Hydro One Networks Inc.

EB-2020-0265 – Hydro One Networks Inc. Leave to Construct Application – Hawthorne to Merivale Reconductoring Project – Interrogatory Responses

OEB STAFF INTERROGATORY #1

Figure 1 - Transformer Station Facilities within the West Ottawa Area

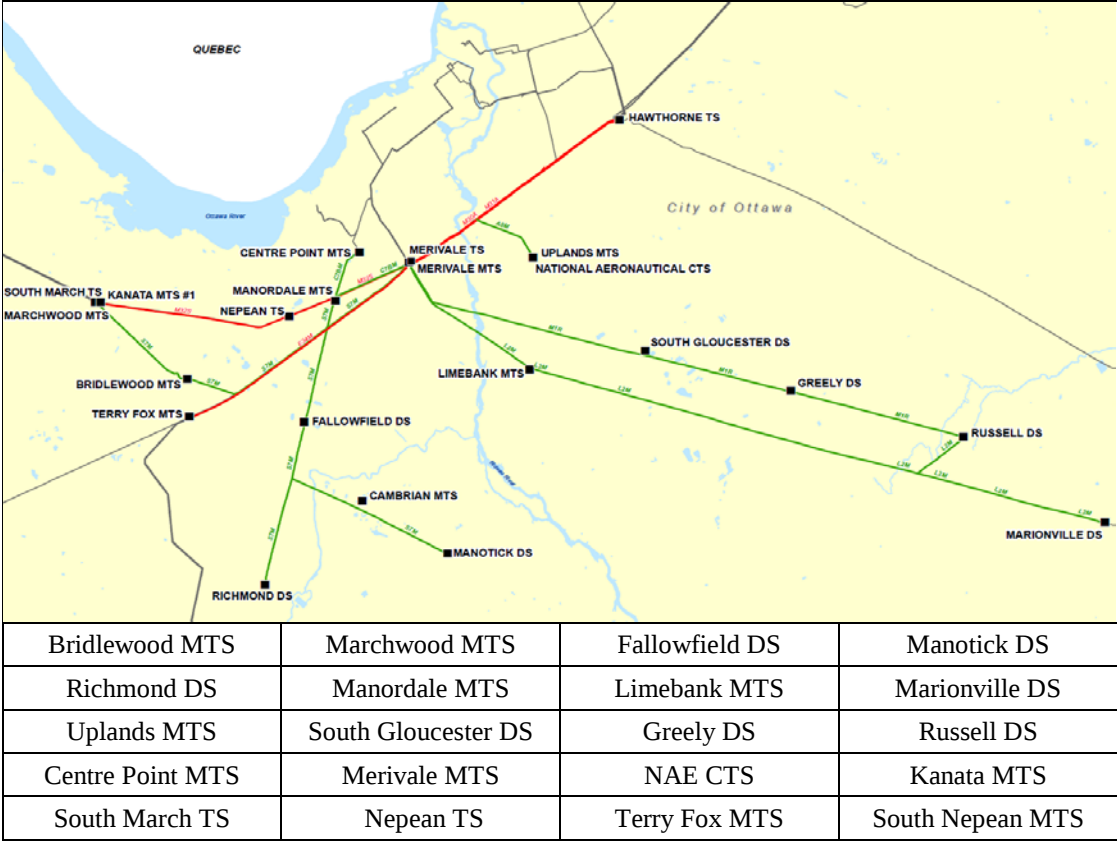
- b) Please define “west Ottawa” (e.g. show regional boundaries). Which transformer stations or other customer connections are included in this area?
- c) Please provide five years of historical demand and 15 years of demand forecast information for west Ottawa. With respect to the provided information, please specify:

b) The term “west Ottawa” refers to an area electrically supplied from Merivale TS. The transformer stations included in this area are shown in Figure 1 below.
